Product Change Notification / ALAN-15FPNL260

eSign# E000077600 Final Notice: Implement change of memory density from 4GB to 2GB on selected Microsemi M2GLxx, RT4Gxx and 5962-16xx device families available in various packages.

Subject: RTG4, SmartFusion2, and IGLOO2 DDR Controller Memory Density Support

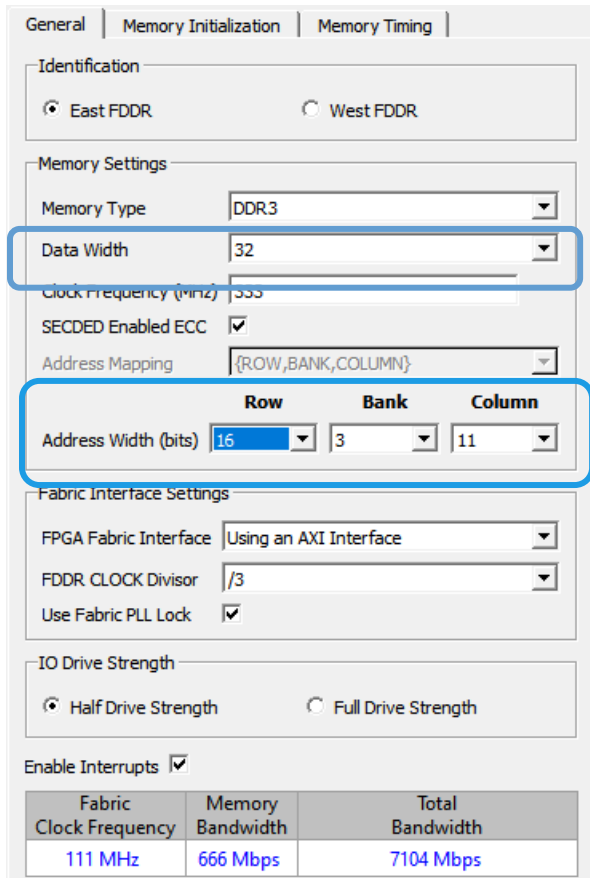
FDDR/MDDR that are configured to access a 4GB DDR memory space (that configures MSB of the 32-bit AXI address to the 4GB DDR memory address) will generate incorrect DDR memory addresses whenever the MSB of the AXI address is asserted. This scenario will result in functional errors in simulation and hardware testing. Designs must not use a DDR memory organization that will exceed a 2GB AXI address to access the entire memory space.

FDDR/MDDR configurations that do not map the MSB of the 32-bit AXI address to the DDR memory address are not affected. In other words, if the AXI address does not exceed a 2GB address space, there is no application impact. Designs with memories greater than 2GB can only access up to 2GB of the memory.

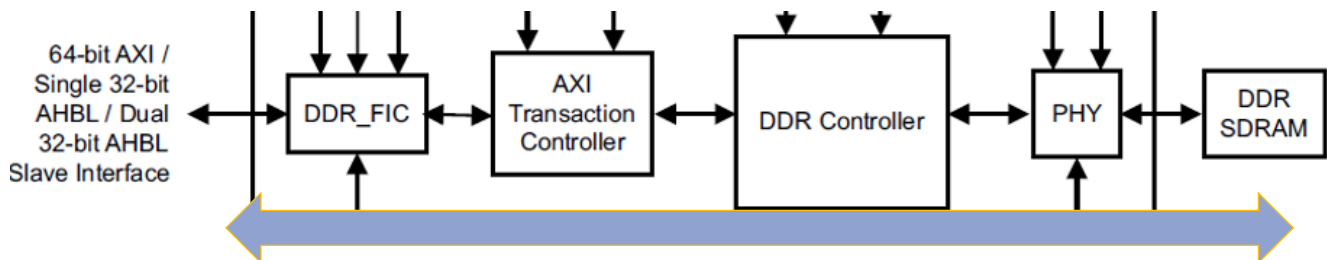
How to assess if configuration of memory controller is addressing more than 2GB.

From the Libero Configurator, below

- Total LPDDR/DDR2/DDR3 address bits = Row+ Bank + Column
- Total LPDDR/DDR2/DDR3 addressable data bits = $2^{\text{address bits}} * \text{(word size aka Data Width)}$
- Total LPDDR/DDR2/DDR3 addressable bytes = $(\text{addressable data bits})/8$

Example: Row = 16, Bank = 3, Column = 11

Total LPDDR/DDR2/DDR3 address bits = 30

Total LPDDR/DDR2/DDR3 addressable data bits = $2^{30} * 32 = 34,359,738,368$

Total LPDDR/DDR2/DDR3 addressable bytes = $34,359,738,368/8 = 4,294,967,296 = 4GB$

- Ensure that the Libero FDDR/MDDR configuration does not map the AXI address to a 4GB DDR memory address.

- Designs with memories greater than 2GB can only access up to 2GB of the memory.
